Service Bulletin

Bulletin No.: Pl0699B

Subject: Gauge Fluctuation, Various DTCs, Wiring Harness Chafing/Rubbing on A/C Line

Models: 2011-2013 Chevrolet Silverado

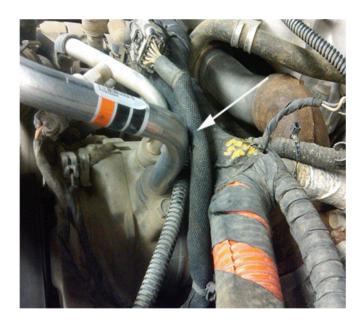
The engine wiring harness may be rubbing on the A/C line.

Repair the wiring harness and install a tie strap to the area shown above. Refer to SI for wiring repairs.
